Planning Application Ref: AW/246/19/PL

Location: Land Adjacent to 34 Wakefield Way Aldwick PO21 3RS

Description of works: Erection of 1 No. 2 storey end of terrace house

Tree Officer / Parks and Greenspace Team

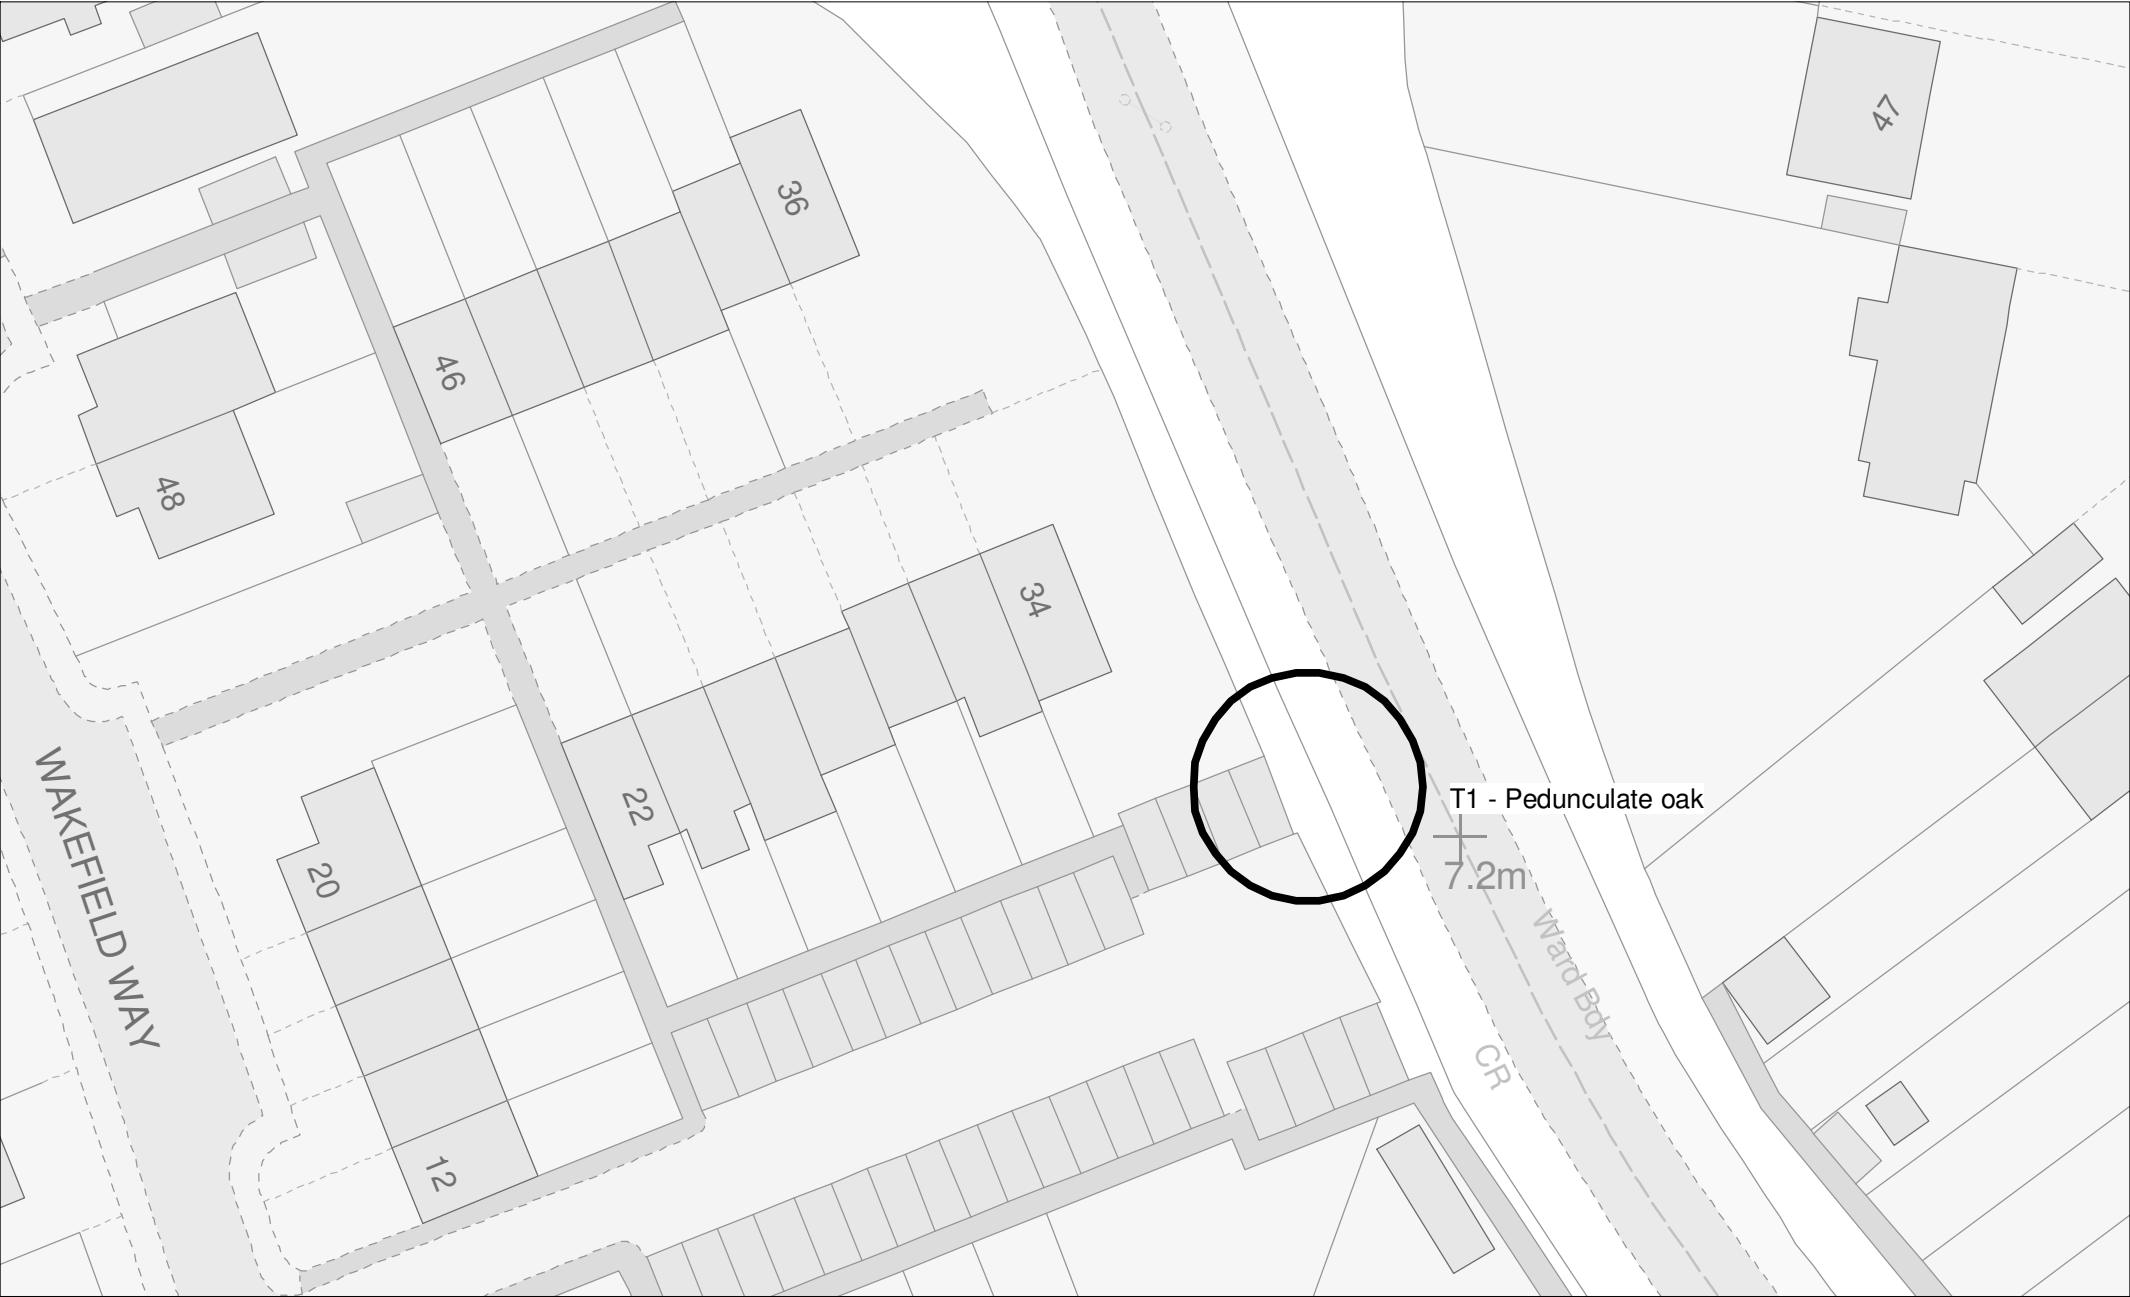
- The use of circular Root Protection Areas is typical and usually adequate but in truth is rarely an informative representation in the built environment. In this case it clearly does not reflect the likely area which contains sufficient roots and rooting volume to maintain the tree's viability. A revised polygon which abandons the inclusion of carriageway/footway and captures much more of the existing garden and verges would be a realistic representation. It follows that the actual extent of root protection area intrusion proposed by this scheme is far more extensive than that which has been illustrated on the TRP plan.

- The RPA of T05, a potentially high value tree (of landscape and public amenity value, which contributes greatly to the verdant character of the area) has not been accurately represented. As such, the extent of RPA intrusion has not been satisfactorily demonstrated.
- I find the likely extent of RPA intrusion problematic and the associated high risk of short and long-term damage to T05 is unlikely to be adequately mitigated by engineering solutions at this site.

- I recommend the making of a Tree Preservation Order in respect of **T05** to preserve its place in the landscape and better control its management. I attach a TEMPO form and GIS plan for this purpose.
- I recommend **REFUSAL** for this scheme.
